SPIRE-RAL-NOT-001194

SPIRE CRYOHARNES OVERSHIELDS INTERNAL TO THE CVV.

SPIRE cryo-harness internal overall shield

Cryostat shielding efficiency final assumption

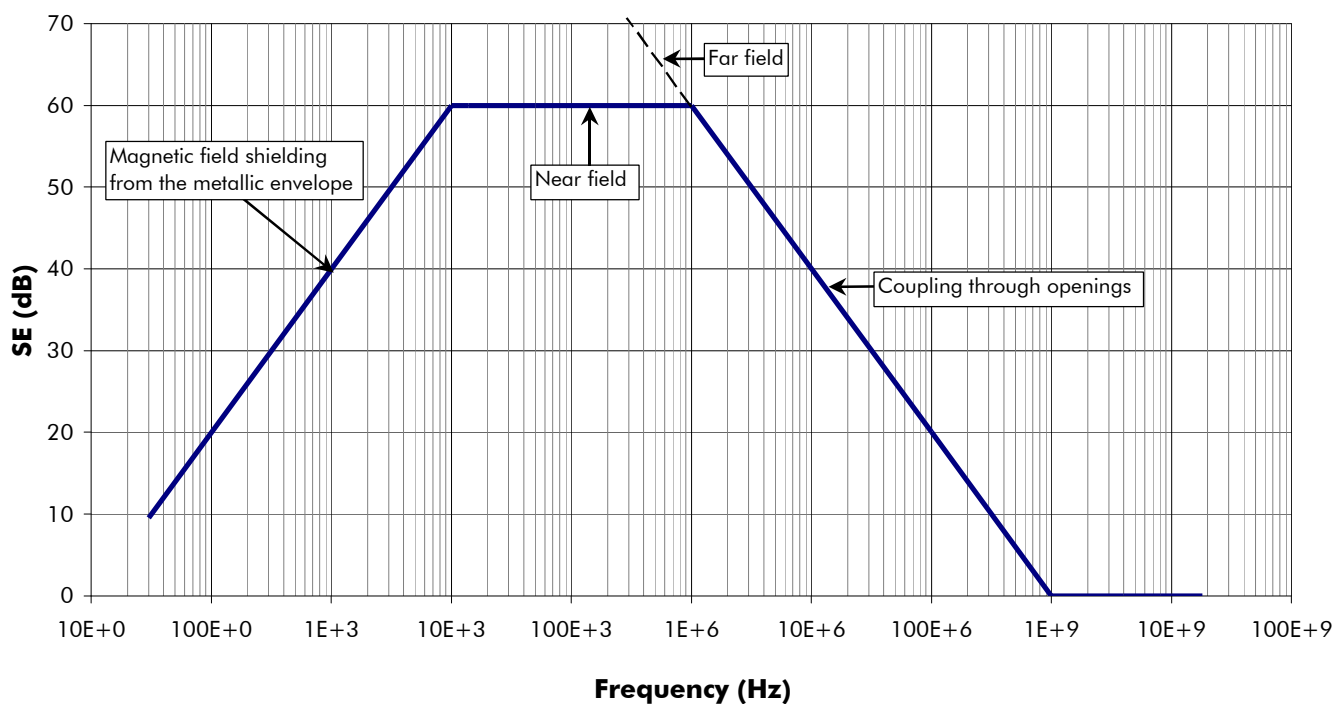
The only changes to H-P-ASPI-LT-1086 that this implies are on page 2, below the diagram, where a form of words might be:

“The following factors will need to be evaluated:

- i. the definition of how the shields could be implemented and an estimate of their resulting HF screening efficiency
- ii. any results from EMC tests or computations, e.g. with the HPLM EQM.

“Astrium should note that these or other factors may indicate that the overshields should be added into the PDR baseline as defined on the first page of this Fax., and no plans should be proceeded with that preclude this from being invocable.”
